ARCHITECTURAL REVIEW BOARD MEETING
CITY HALL, 385 SOUTH GOLIAD STREET, ROCKWALL, TEXAS
AUGUST 26, 2025 IN THE CITY COUNCIL CONFERENCE ROOM AT 5:00 PM

PROJECT COMMENTS

PROJECT NUMBER: SP2025-033
PROJECT NAME: Site Plan for 102 West Bourn Street
SITE ADDRESS/LOCATIONS: 102 West Bourn Street, Rockwall, TX, 75087

08/21/2025: SP2025-033: Site Plan for 906 S Goliad

SITE & LANDSCAPE PLAN
KIM TIMPA LAW OFFICES
906 S GOLIAD @ BOURN TX
CITY OF ROCKWALL
ROCKWALL COUNTY, TEXAS

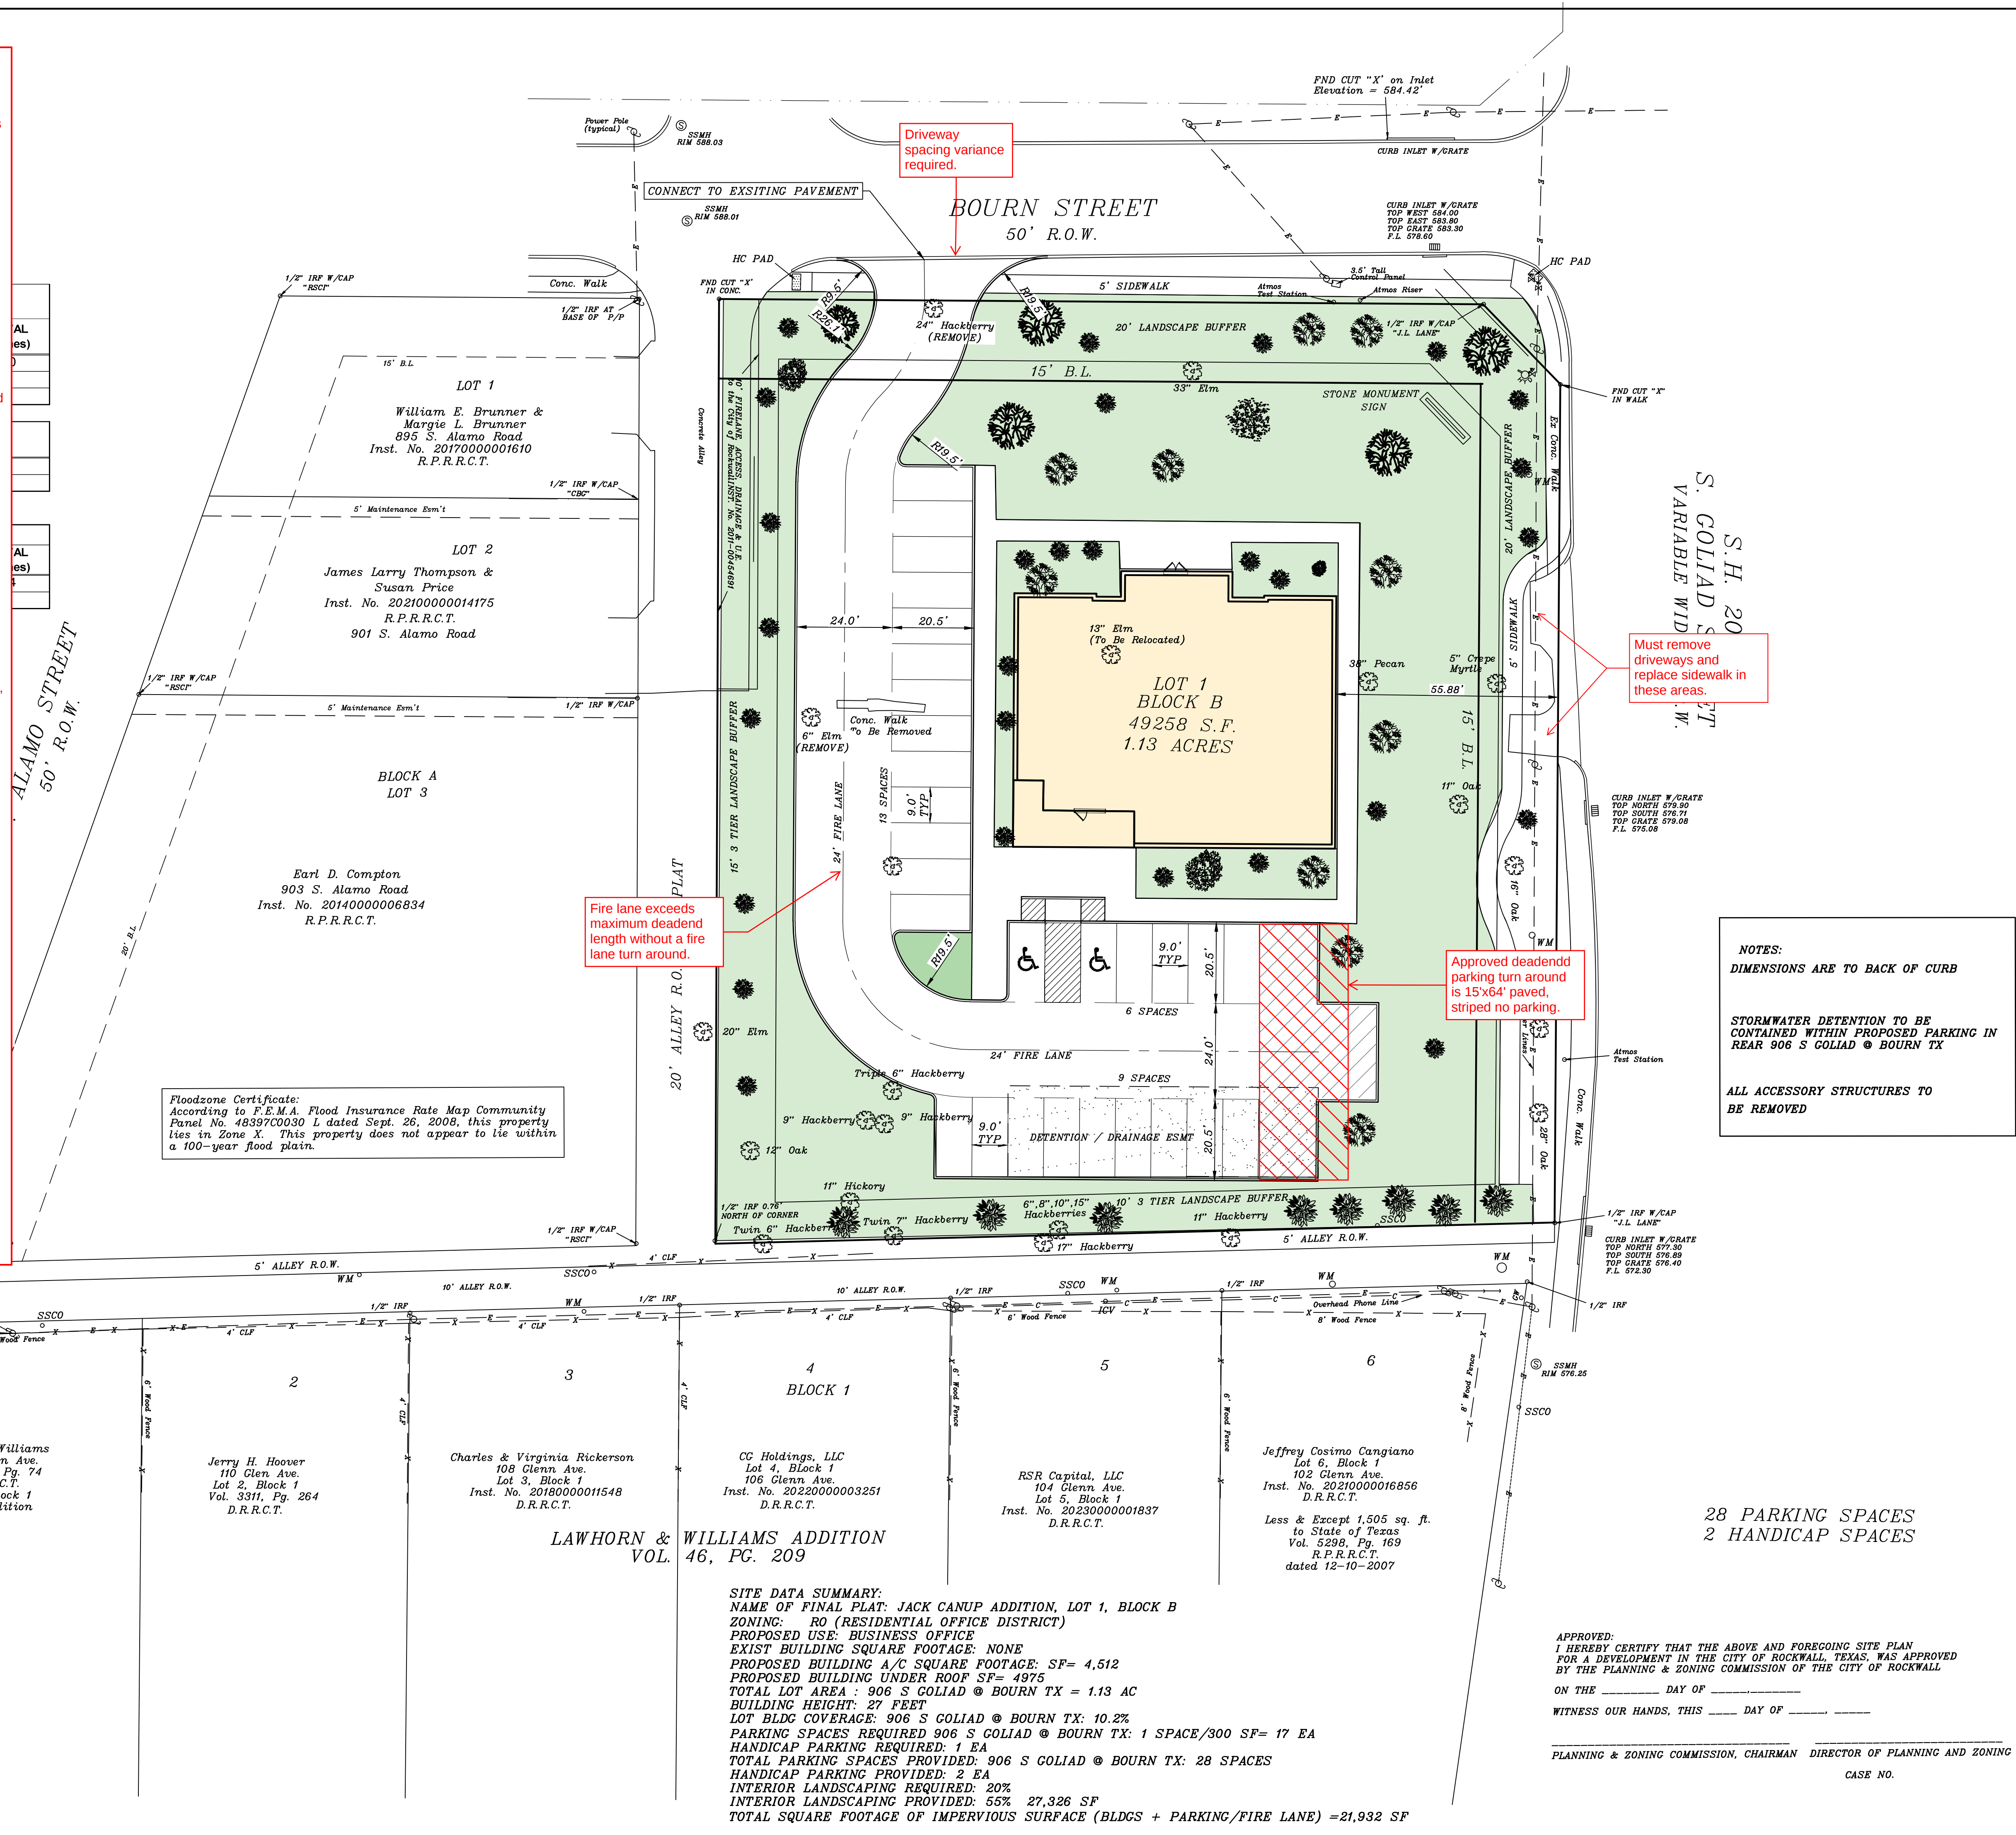
- (1) Separate the Landscape Plan and Site Plan into two (2) separate documents.
- (2) Pad mounted utility equipment, and air conditioning units, shall be screened from horizontal view from any adjacent public street and from any adjacent property. Utility equipment and air conditioning units shall be screened utilizing plantings berms, or walls matching the main structure. (Subsection 01.05.C, Article 05, of the UDC) Please indicate on your site plan if there are any pad mounted utility equipment. Utility equipment will be subject to screening if found later at engineering or building permit.

- (3) Provide the square footage of the proposed building on the site plan. (Subsection 03.04.B, Article 11, UDC)
- (4) Provide the perimeter dimensions of the building. (Subsection 03.04.B, Article 11, UDC)

- (5) Indicate all drive/turning radii. (Subsection 03.04.B, Article 11, UDC)
- (6) Provide adjacent street centerlines for Bourne Street and S. Goliad. (Subsection 03.04.B, Article 11, UDC)

- (7) Provide median breaks in adjacent streets [S. Goliad]. (Subsection 03.04.B, Article 11, UDC)
- (8) Provide the type and depth of paving material. (Subsection 03.02, Article 06, UDC)

- (9) All portions of the parking lot shall be behind the front façade of the building. (Planned Development District 62 [PD-62]; Ordinance No. 05-42)
- (10) Show existing driveways located off of S. Goliad as "to be removed".

- (11) Will there be a dumpster enclosure? If using polycarts, they must be either screened with a dumpster enclosure or brought inside. (Subsection 01.05.B, Article 05, UDC)

(12) Please provide the required 20' residential adjacency landscape buffer with three-tiered screening along the west and south property lines. Three-tiered screening comprises of a berm, a row of canopy trees 20' on center, a row of accent trees, and a row of shrubs. The shrubs will need to screen the headlights of cars so plant that section accordingly. (Subsection 01.06, Article 06, UDC) The 10' and 15' residential adjacency buffer will require an exception from the Planning and Zoning Commission.

(13) The Landscape buffer along Bourne Street and S. Goliad Street requires a berm and one (1) canopy tree and one (1) accent tree per 50-linear feet of frontage. (Subsection 05.01.B, Article 08, UDC)

(14) Vitex is not an approved tree within Landscape Buffers. Would suggest moving closer/around the building. (Appendix C, UDC)

(15) Please provide a table showing the number, species, and caliper of trees being removed. (Table 2, Article 09, UDC)

(16) All parking spaces must be within 80 feet of a canopy tree. (Subsection 05.03.E, Article 08, UDC)

(17) Provide a note indicating irrigation will meet the requirements of the UDC. (Subsection 05.04, Article 08, UDC)

- 08/22/2025: 1. Driveway spacing variance required.
2. Must remove driveways and replace sidewalk in these areas.
3. Approved deadened parking turn around is 15'x64' paved, striped no parking.
4. Fire lane exceeds maximum dead-end length without a fire lane turn around.

DEPARTMENT	REVIEWER	DATE OF REVIEW	STATUS OF PROJECT
FIRE	Ariana Kistner	08/18/2025	Approved w/ Comments
08/18/2025: The dead-end fire lane shall not extend beyond 150 feet onto the property.

1 PHOTOMETRIC SITE PLAN
1/16" = 1'-0"

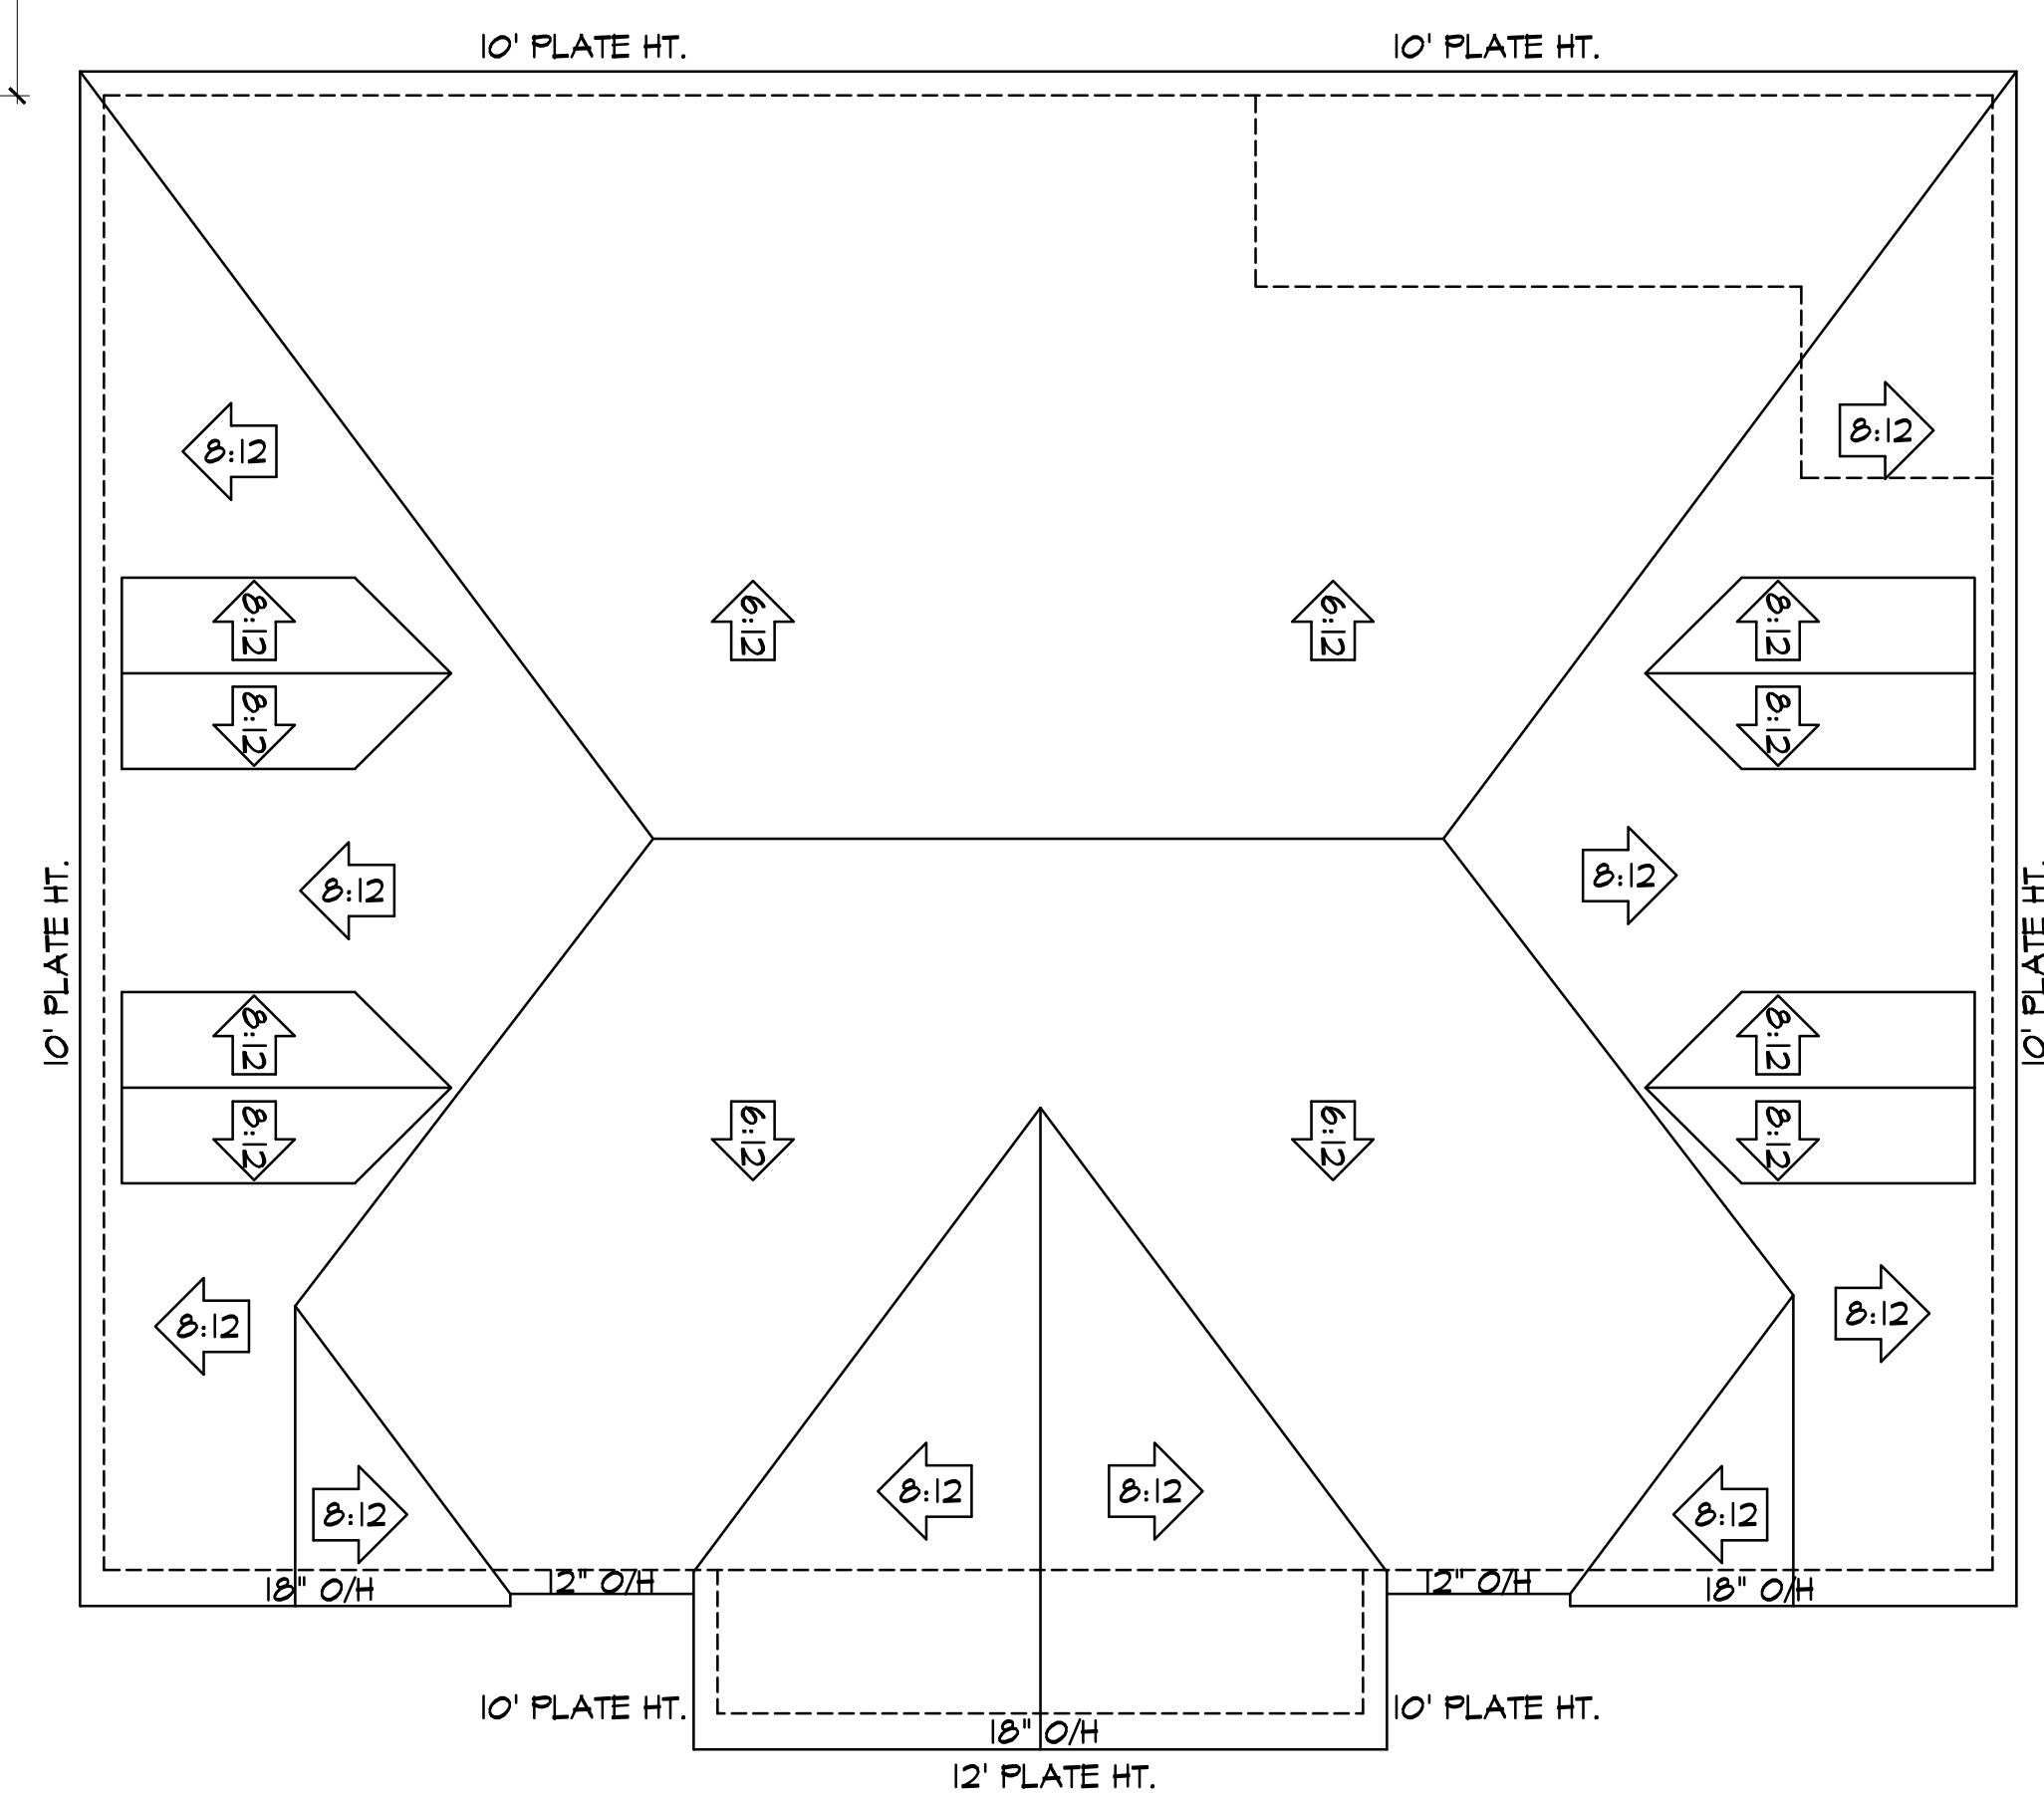
(1) Please provide lighting cut sheets that indicate the wattage for each exterior lighting fixture. Light sources (e.g. light bulbs) shall be oriented down and toward the center of the site or shielded so as to not be visible from the property line. (Subsection 03.03.A, of Article 07, of the UDC)
